Project: Marsh Run II Redevelopment
 Address: 11816 Wayzata Blvd

April 11, 2023

Re: Marsh Run II Redevelopment

SHEET
C3.01
REV.

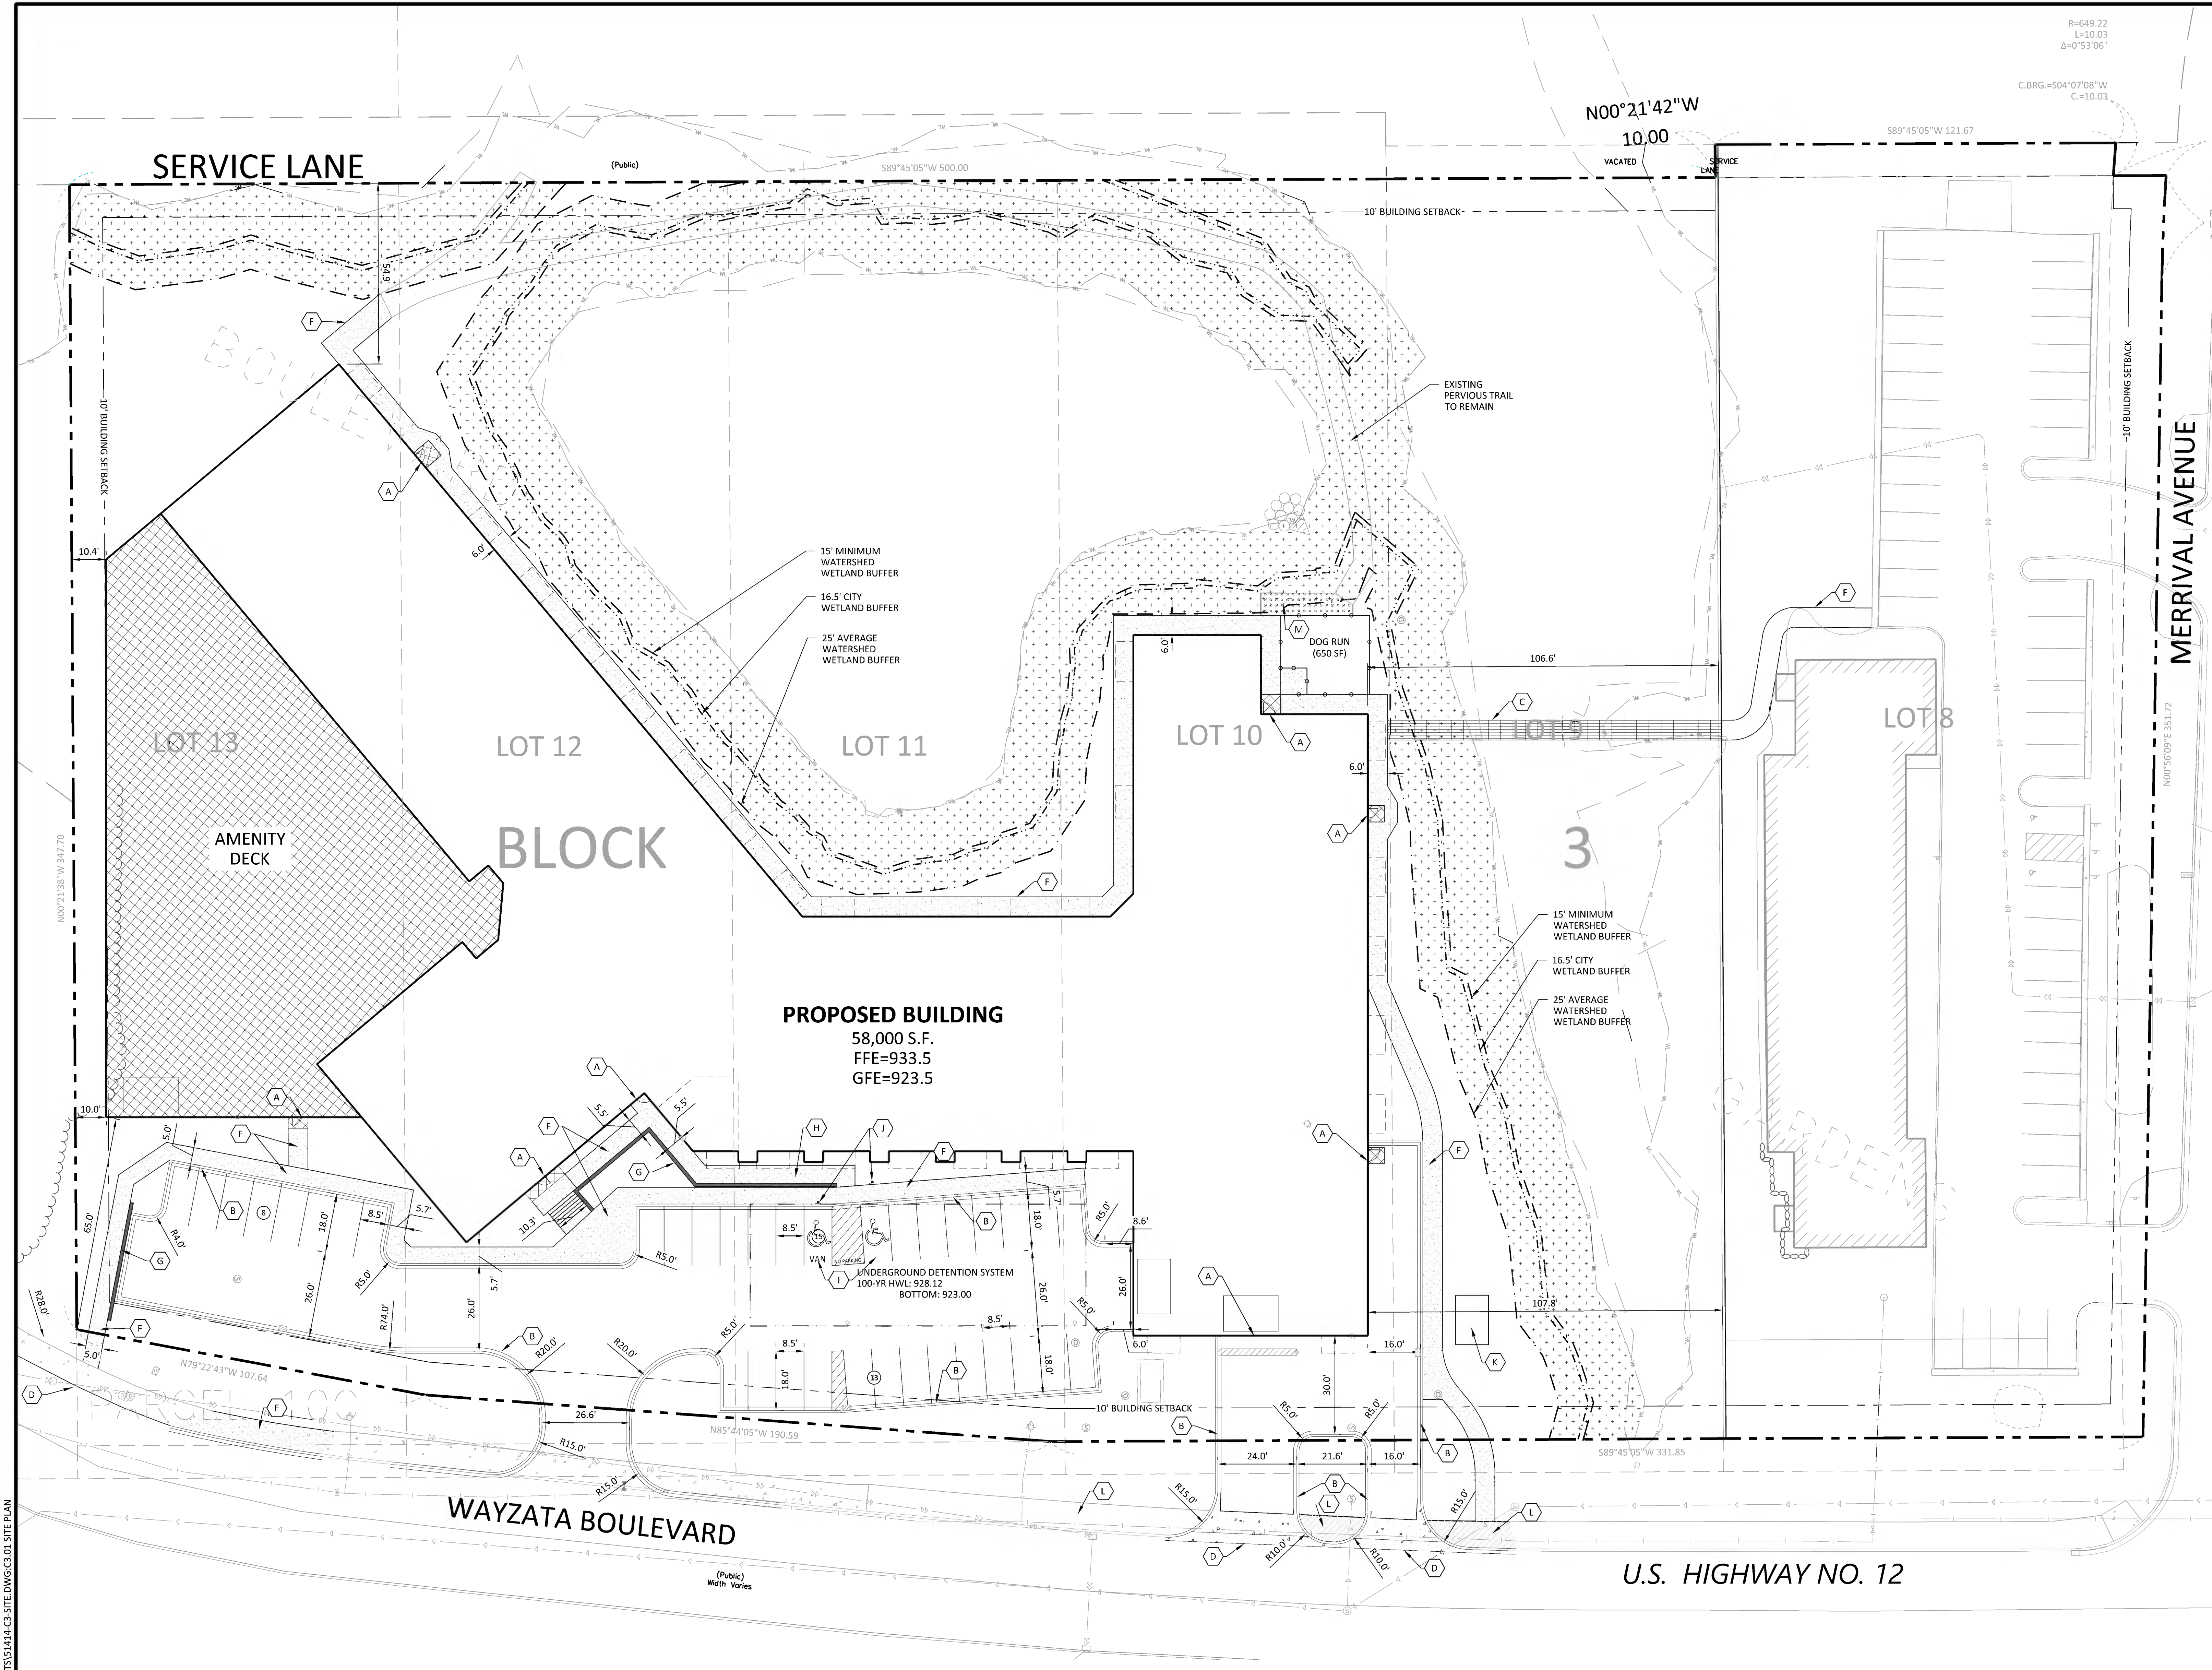
City staff received a Traffic Study from SRF on March 24, 2023, which resulted in recommendations to make an adjustment to the site plan that was previously submitted. The recommendation was to shift the proposed western drive entrance 100' east of the existing site entrance. This was due to the need for safe left-turning maneuvers, and meet the recommended AASHTO gap time of 7.5 seconds from when vehicles become visible on the main sight line to when they cross the proposed access location. The previous proposed access drive would have a gap time of 6.75 seconds. With the new proposed western site entrance, the project should meet or exceed the recommended gap time of at least 7.5 seconds and instead be closer to 8-8.5 seconds.

Moving the western site entrance approximately 150 feet from the previously proposed entrance had cascading impacts to the previously submitted site plan. This is due to grades on project site – grades fall from east to west along Wayzata Blvd, but entering the site fall from west to east. Site and building plan configurations were adjusted to accommodate the appropriate and/or desired maximum slopes of the site drive and surface parking. A full list of the site plan and south elevation changes from the original submission in February include:

- Overall finish site grade adjusted near building entry/new site entry to allow for proper slopes into the site and cross slope through the surface parking/circulation area.
- The new lower grade required a rework of the front entry. Shifting the entry door out to accommodate stairs and accessible pathway to catch the grade.
- The Parking entrance into L1 shifted to east wing due to new site entry location for easier circulation and building access.
